SERVICETEKNOTES

PTS101

Personal Test System for Dynamic Characterization of A/D Converters

Figure 1

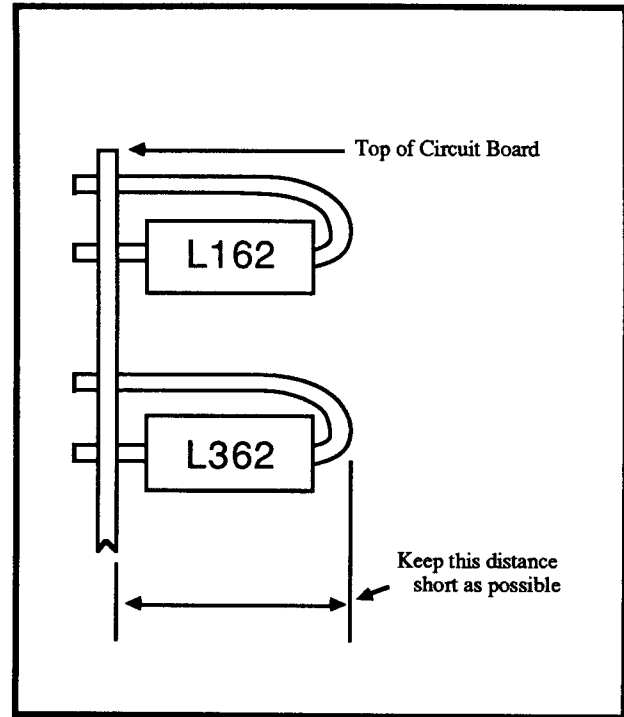
A small amount of residual subcarrier on the 1750 Series display has been traced to crosstalk from the DeMod board to the Vertical Amp board.

To alleviate this problem, Mod #65461 repositions A3L362 and A3L162 on the Vertical Amp board such that the coil bodies are perpendicular to the circuit board (see Figure 1).

Install this mod, as required, using two new coils, P/N 108-0317-00, in the configuration shown to help address residual subcarrier problems.

***Note:** Figures 1, 2, 3, and 4 are found in Pullout "B".

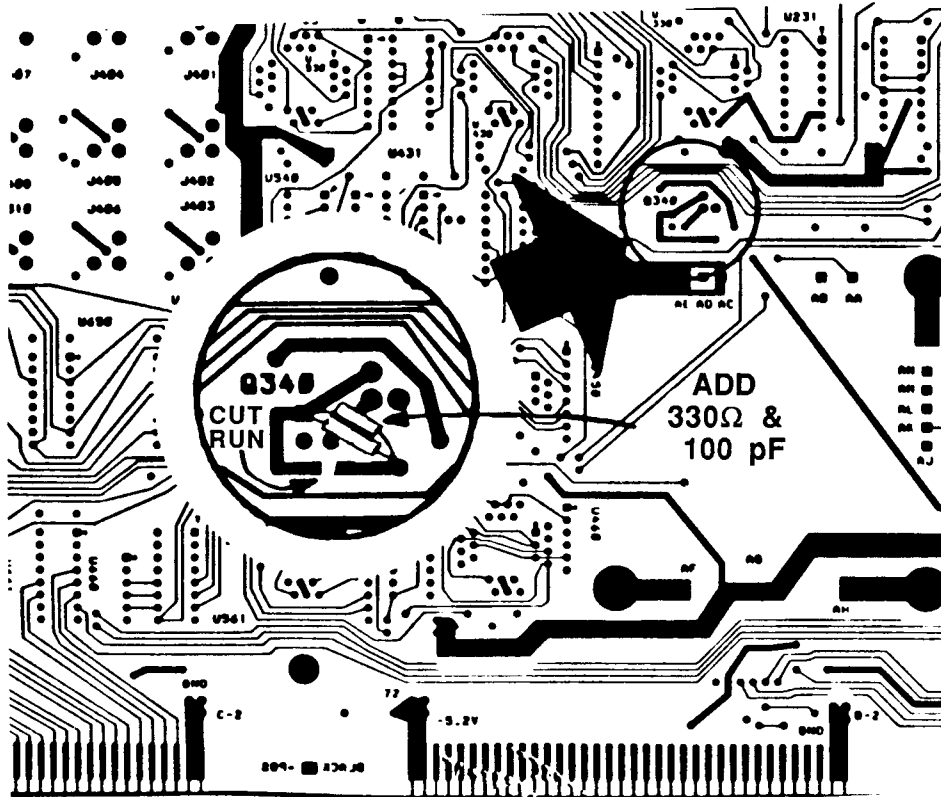
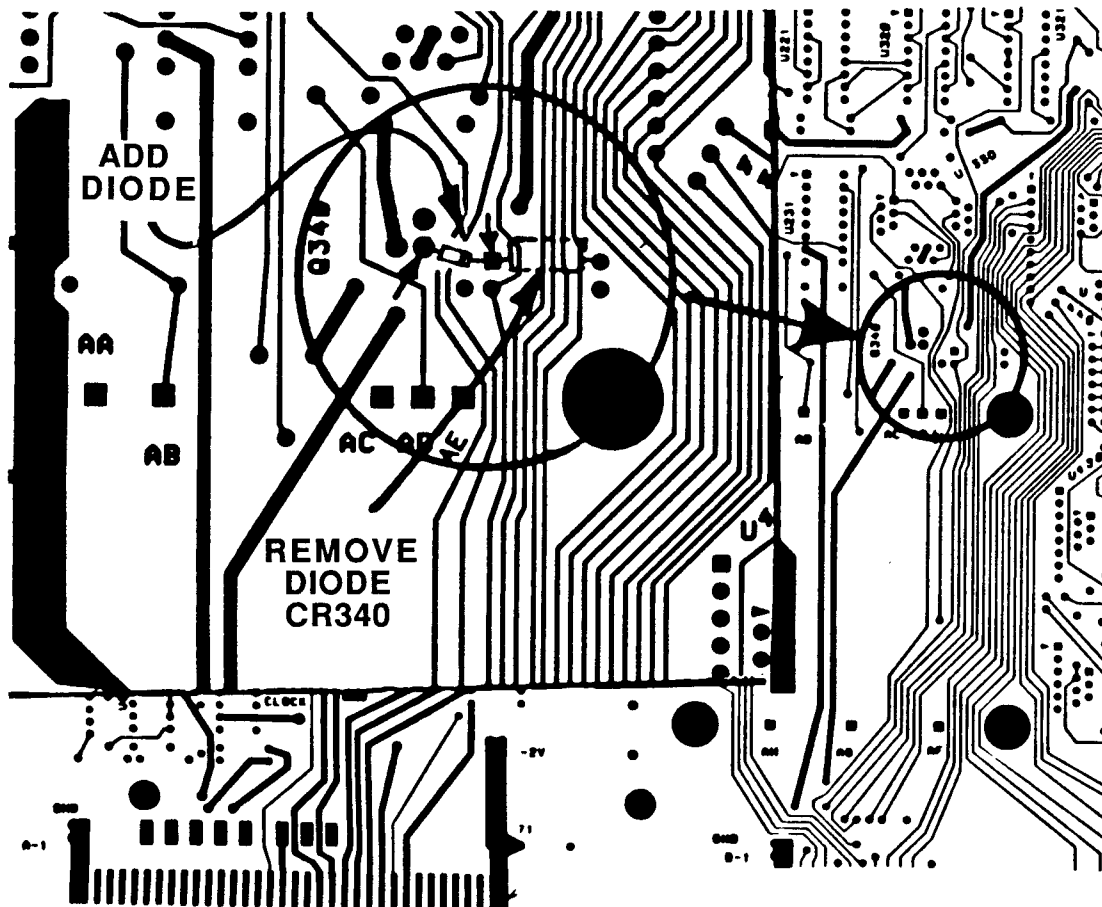
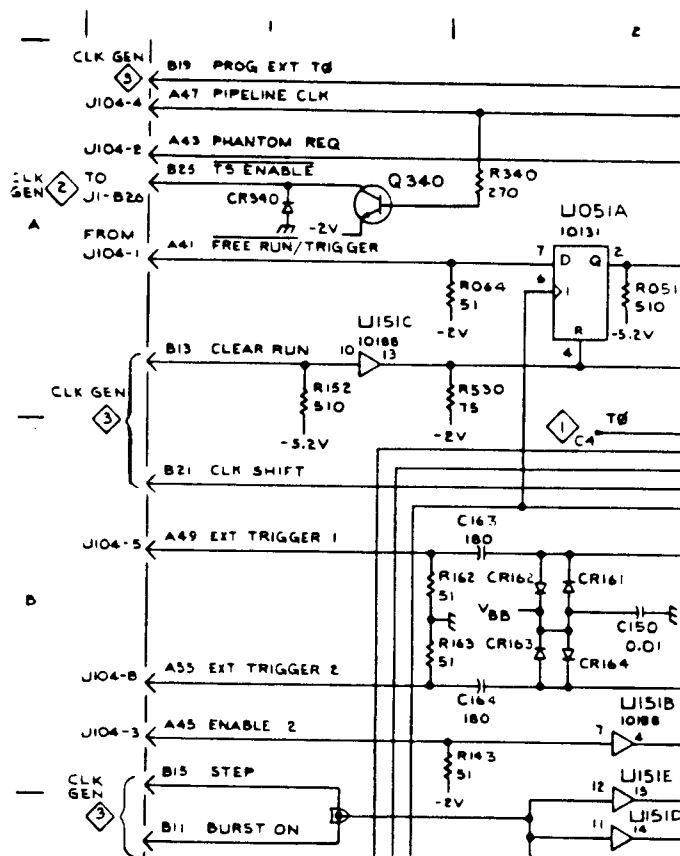
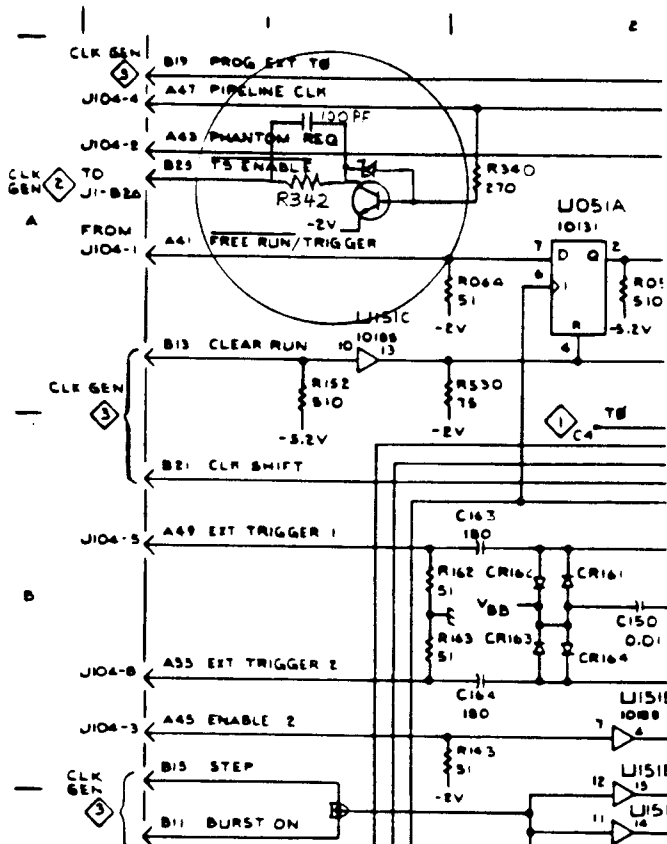
The High Resolution Clock Generator Cycle Length Board, P/N 670-8219-02 is being modified to prevent U221 on the Interface Board from being overdriven. When the input signal to U221 is below the manufacturers specified limit of -0.3 V, logic errors might occur. Before this modification, the data bits used to select the desired clock phase might get corrupted. The modification involves using a voltage divider to attenuate the signal to the flip-flop, U221. A 100 pF capacitor is used to compensate for the slowed falling edge of the TS ENABLE signal. Also, a Schottky diode is added to prevent the ECL to TTL converter transistor, (Q340) from saturating.

1. Cut the circuit board run in the collector circuit of Q340 as shown in Figure 1*. This should be done on the back of the circuit board using an X-Acto knife or Dremel tool.
2. Add the 330 ohm resistor (R342), P/N 315-0331-00, and the 100 pF capacitor (C340), P/N 281-0765-00, as shown in Figure 1.
3. Remove the existing diode (CR340), P/N 152-0141-02, from the component side of the board (Figure 2).
4. Install the new CR340 Schottky diode, P/N 152-0725-01 from Collector to Base of Q340

(Figure 2). The before and after circuit diagrams are shown in Figures 3 and 4.

After the modification, the Cycle Length Board part number changes to 670-8219-03. The Cycle Length Assembly will change to 672-0087-01.

Fig. C-4. Location of 650HR-C black and white reference pulses.

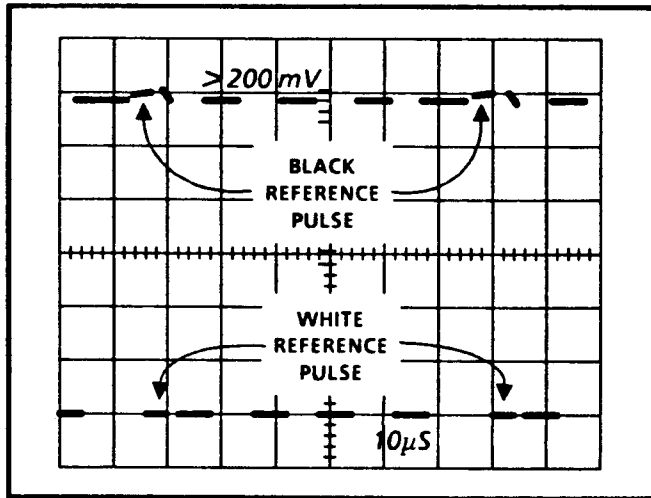
3. Use the Volts/Div Variable control to set the black reference pulse-to-white reference pulse distance to six divisions. See Figure C-4.

4. **ADJUST** - R9238 so the color bar white level is six major and 2.5 minor divisions from the 650HR-C Series CHANNEL 1 black reference. See Figure C-4 for the location of the black and white reference pulses.
